<b>ITEM: 6.6</b>	<b>REPORT SUMMARY MINOR VARIANCE APPLICATION FILE NUMBER A199/23</b>
------------------	--

**MINOR VARIANCE APPLICATION  
FILE NUMBER A199/23  
151, 155 NEW HUNTINGTON ROAD, WOODBRIDGE**

<b>CITY WARD #:</b>	2
<b>APPLICANT:</b>	155 New Huntington Inc.
<b>AGENT:</b>	Baldassarra Architects Inc.
<b>PROPERTY:</b>	151 & 155 New Huntington Road, Woodbridge
<b>ZONING DESIGNATION:</b>	See below.
<b>VAUGHAN OFFICIAL PLAN (2010) DESIGNATION:</b>	Vaughan Official Plan 2010 ('VOP 2010'): "General Employment".
<b>RELATED DEVELOPMENT APPLICATIONS:</b>	None
<b>PURPOSE OF APPLICATION:</b>	Relief from the Zoning By-law is being requested to permit the construction of a retaining wall.

Site Plan

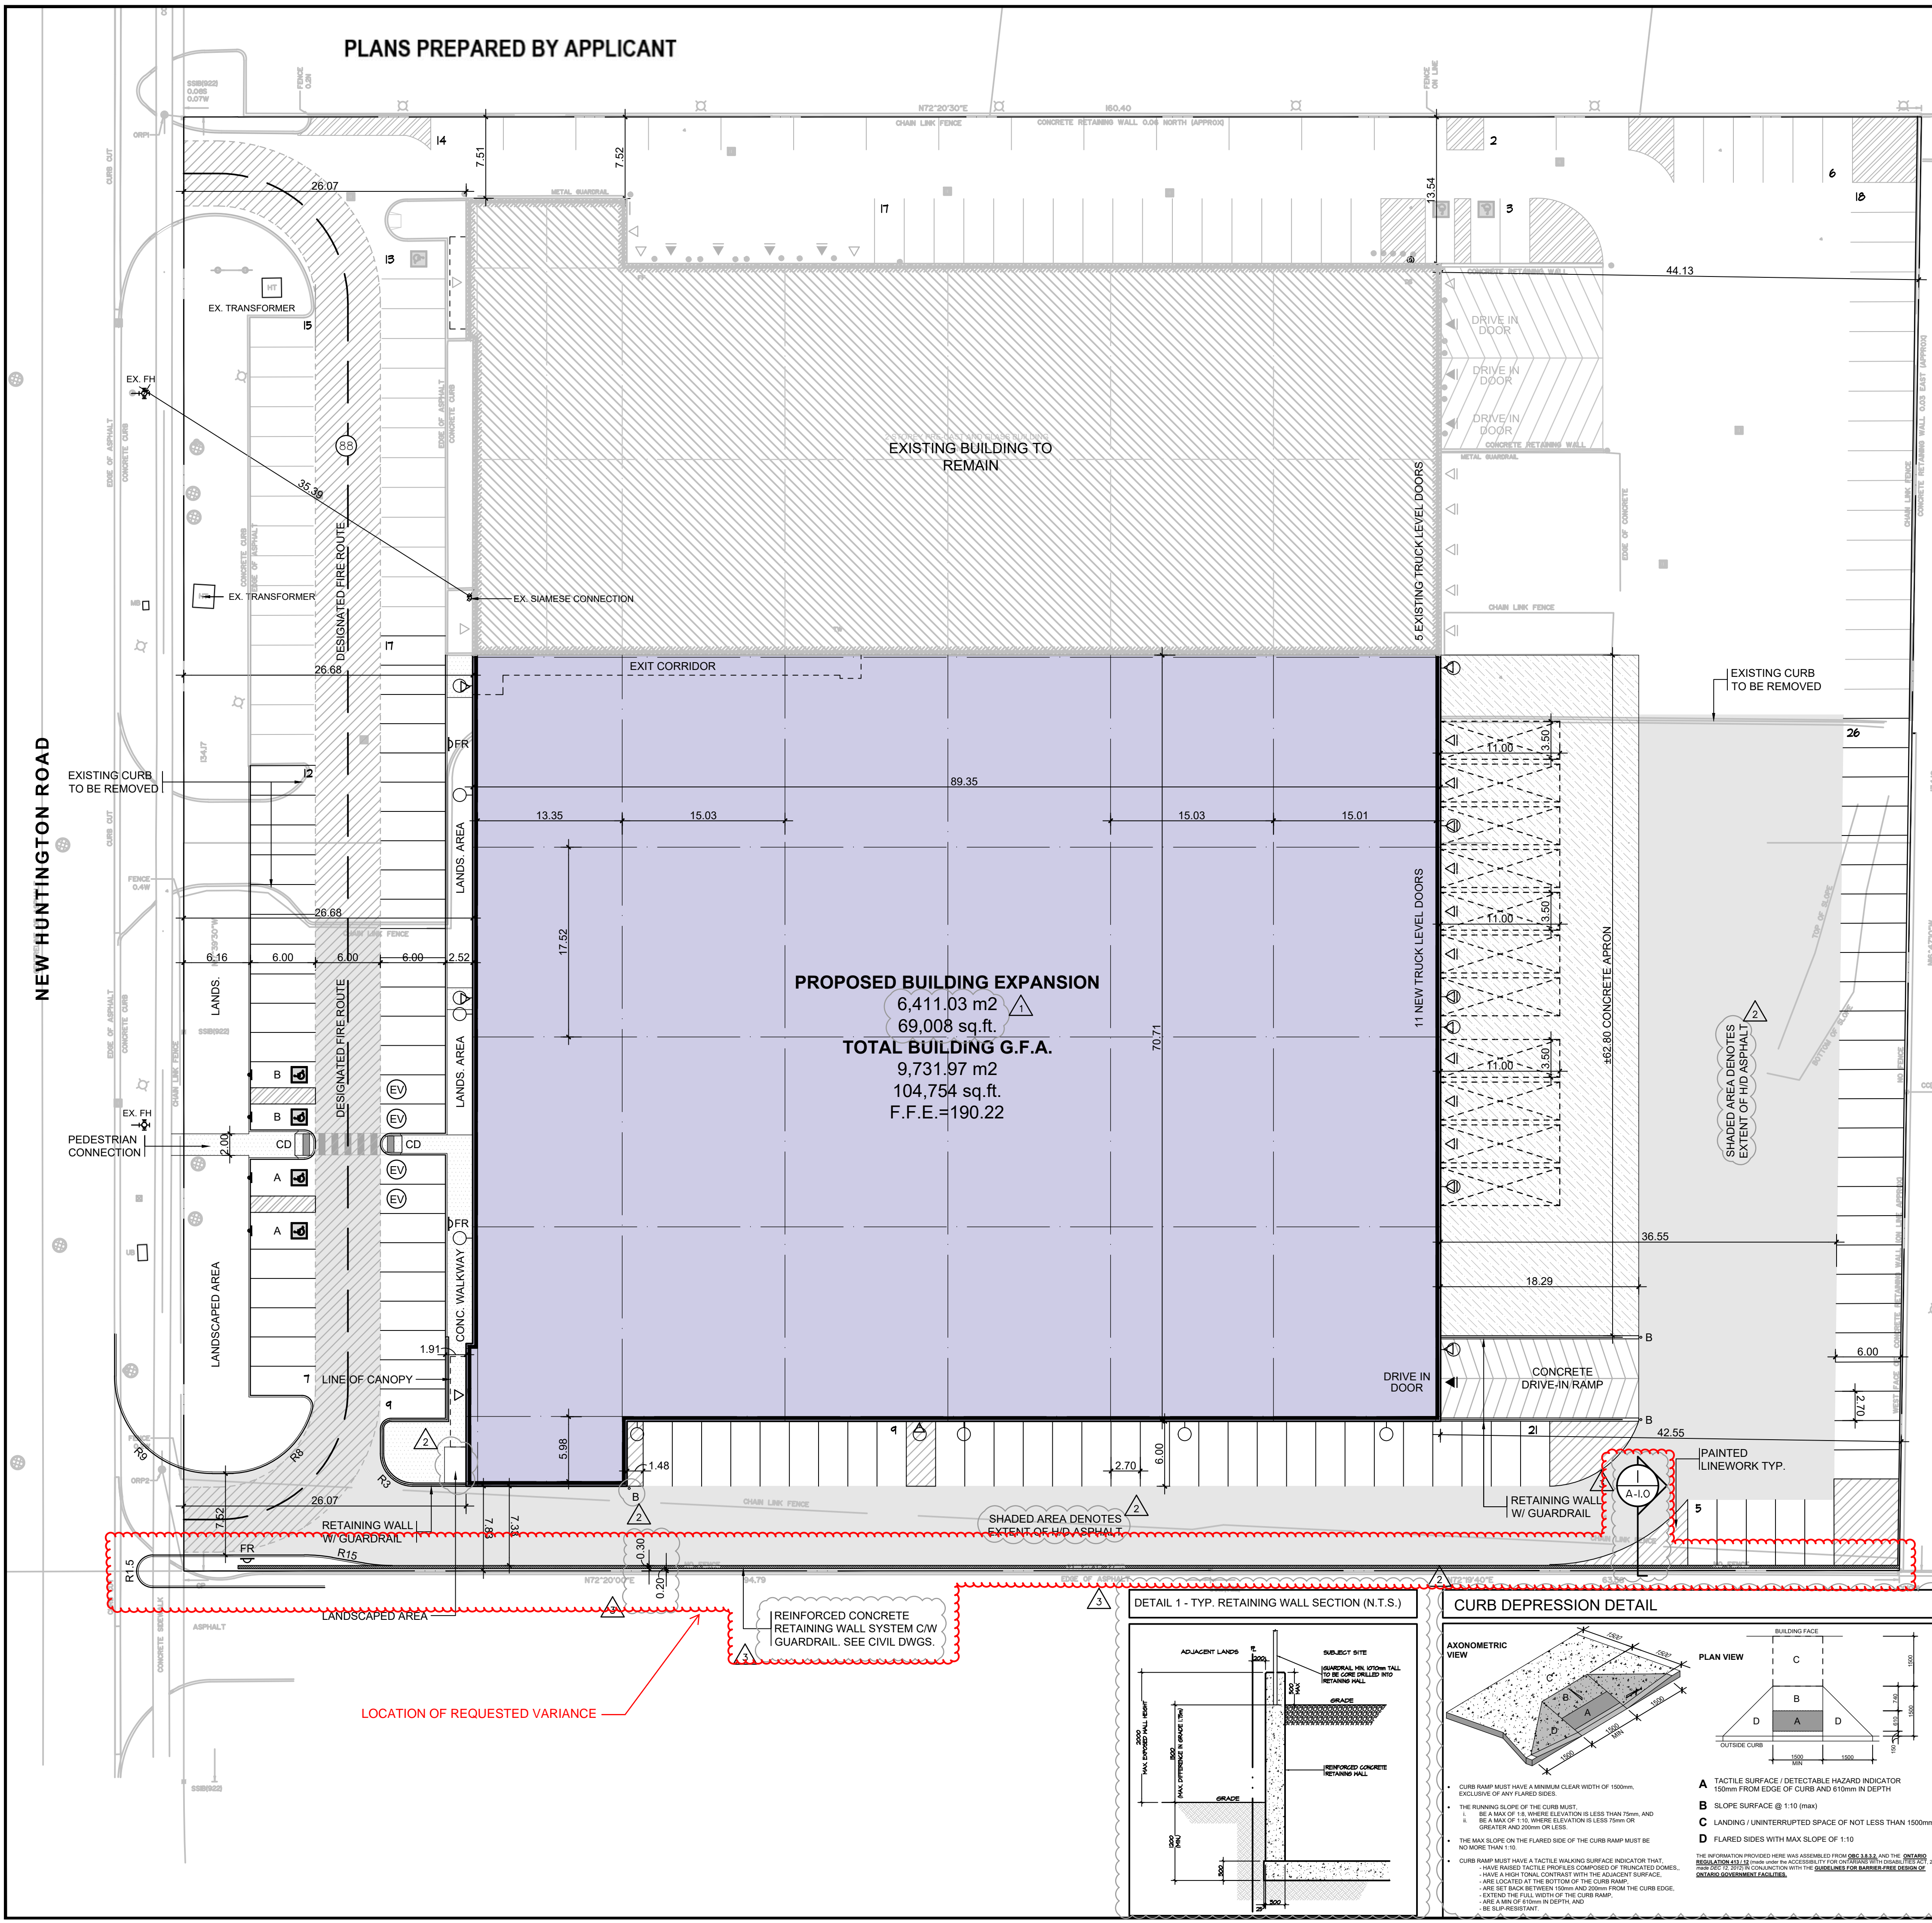
The Development Planning Department has no objection to the proposed variance for the retaining wall. The retaining wall has an exposed face height of 0.85 m when facing south, at its western most point. The wall height gradually increases as it travels eastward until it reaches its maximum height of 1.93 m one third down its length. The retaining wall is form and pour finished concrete which generally requires little maintenance. The wall will not encroach into the neighbouring property and an appropriate area is maintained for maintenance access without the need for entering the neighbouring property. The Development Engineering Department has also reviewed the proposal and has no concerns with the retaining wall. As such, the retaining wall is not anticipated to have any adverse impacts to the neighbouring property.

Accordingly, the Development Planning Department can support the requested variance and is of the opinion that the proposal is minor in nature, maintains the general intent and purpose of the Official Plan and Zoning By-law, and is desirable for the appropriate development of the land.
